Subject: **Request for Modification to Individual Section 404 and 401 permits and Neuse Riparian Buffer Authorization** for construction of the US 70 Bypass. Construction of the US 70 bypass from SR 1300 to East of SR 1556 in Wayne County. State Project No. 6.339002T. TIP No. R-2554BA. Debit \$575 from WBS 34461.1.1.

References: Section 404 Individual Permit issued July 21, 2008 (SAW 2088-0025);
Section 401 Water Quality Certification and Neuse Riparian Buffer Authorization issued May 16, 2008 (DWQ No.20080570).

The purpose of this letter is to request modification to an U.S. Army Corps of Engineers (USACE) Section 404 Individual Permit Modification, as well as a N. C. Division of Water Quality (NCDWQ) Section 401 Water Quality Certification and Neuse Riparian Buffer Modification. In addition to the cover letter, this modification request also includes illustrations for the permit sites involved.

Jurisdictional Channel North of Site 11 located on DOT owned property.
 42.8 meters in length from outlet of a concrete crossline pipe to DOT ROW line.

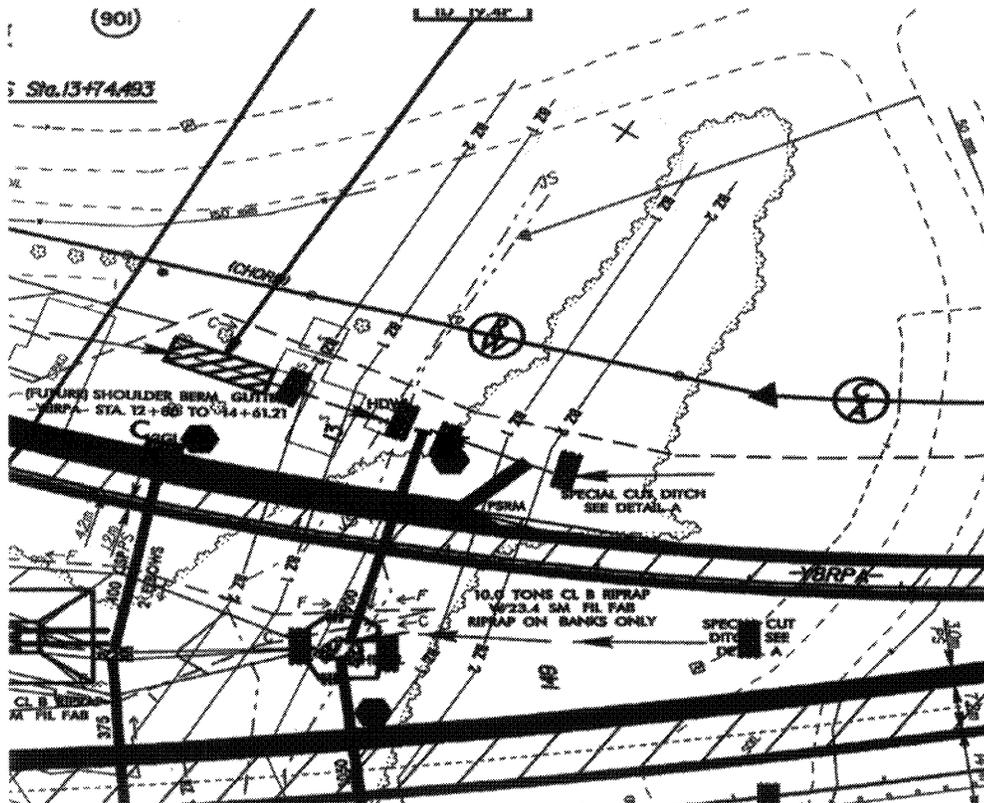
Just north of the permitted impacts to Site 11 (R-2554 BA section) is a small stream that will be impacted by the borrow pit the contractor plans to dig. It was determined during a site visit with the USACE, NCDWQ, and NCDOT staff on February 10, 2009, that the Skaggs method would be used to determine a setback of the pit from the stream channel. Knowing that the pit will impact the hydrology of this first order stream NCDOT plans to do on-site mitigation at Site 10. At Site 10 there is a wetland that has a drainage feature that flows in the direction of the new construction. As discussed with USACE and NCDWQ staff, NCDOT proposes to create a drainage pattern within the already permitted mechanized clearing limits. This new feature would redirect water through a channel to reduce water backup on the fill slope and improve the drainage pattern of the wetland.

Impacts of 42.8 m (140 ft) will occur to the stream north of Site 11. The length of the new channel at Site 10 is 83.18 m (273 ft), base width is 0.9 to 1.2 m (3 to 4 ft), and the depth is 0.6 m (2 ft).

FROM STA. 139+80 TO STA. 140+63 -L- RT

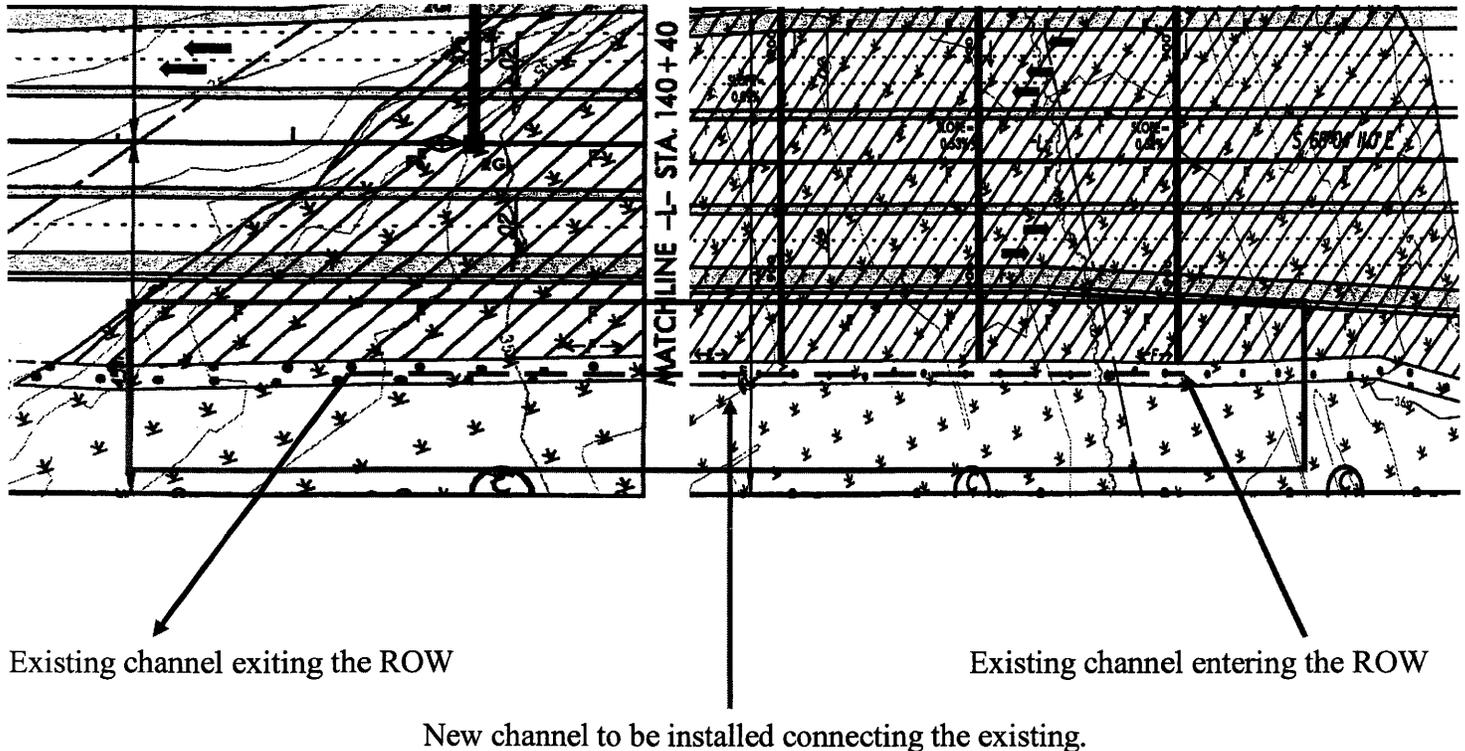
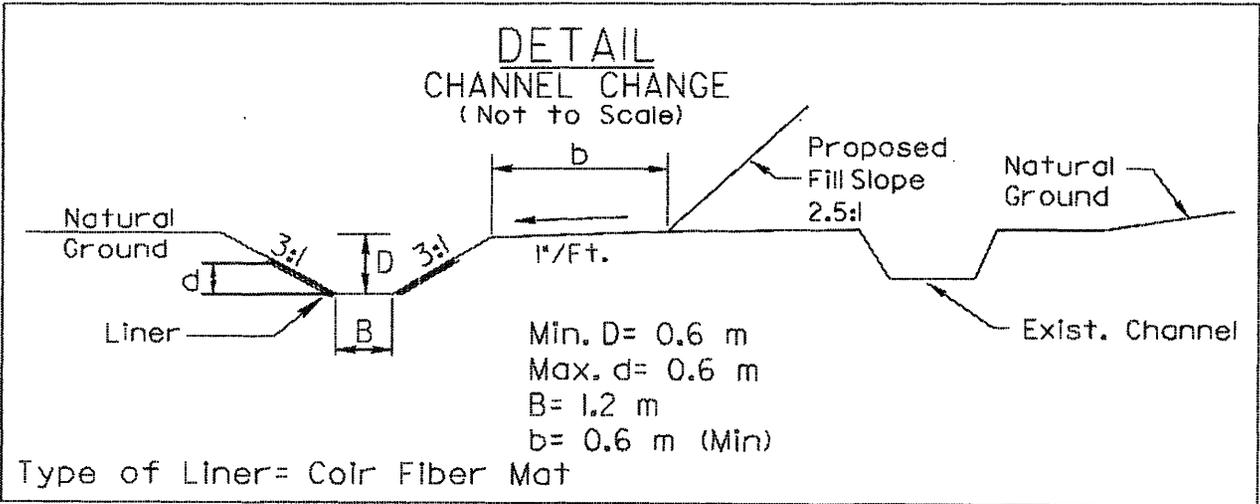
Length of new channel = 83.18 meters
 Base Width of new channel = .9 – 1.2 meters
 Depth of new channel = .6 meters
 Streambank reforestation to include Black Willow and Silky Dogwood live stakes.
 Due to existing wooded area immediately South of the new channel and embankment immediately North of the channel, no floodplain plantings will be installed.
 No water will be turned into the channel until adequate vegetation develops.

Site 10 New channel length	=	83.18 meters
Site 11 Existing channel length	=	<u>42.8 meters</u>
Net Gain of channel	=	40.38 meters

Location of mechanized clearing zone and future location of new channel (Site 10)

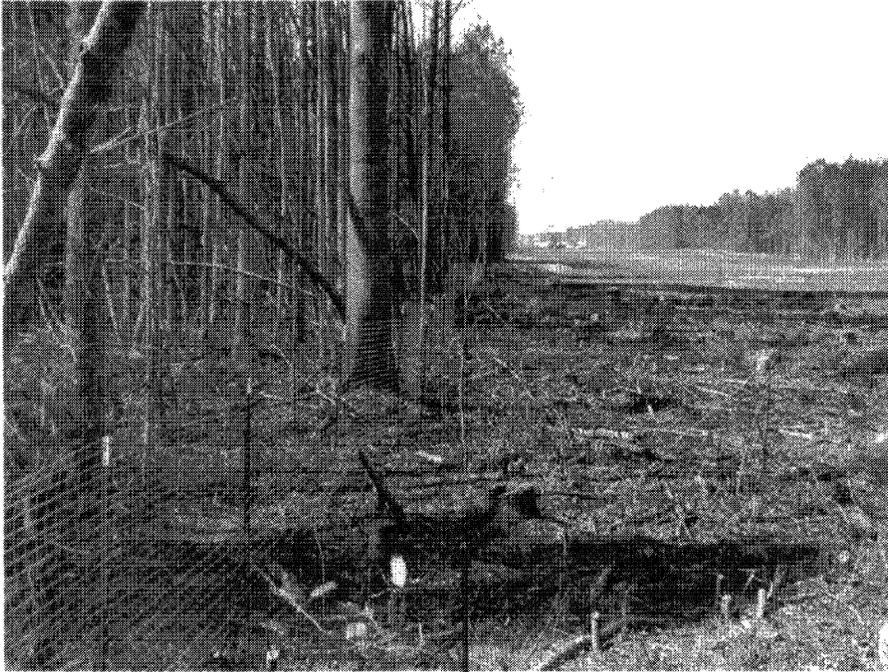
Existing channel that will be “short circuited” along fill of future fill slope (Site 10).
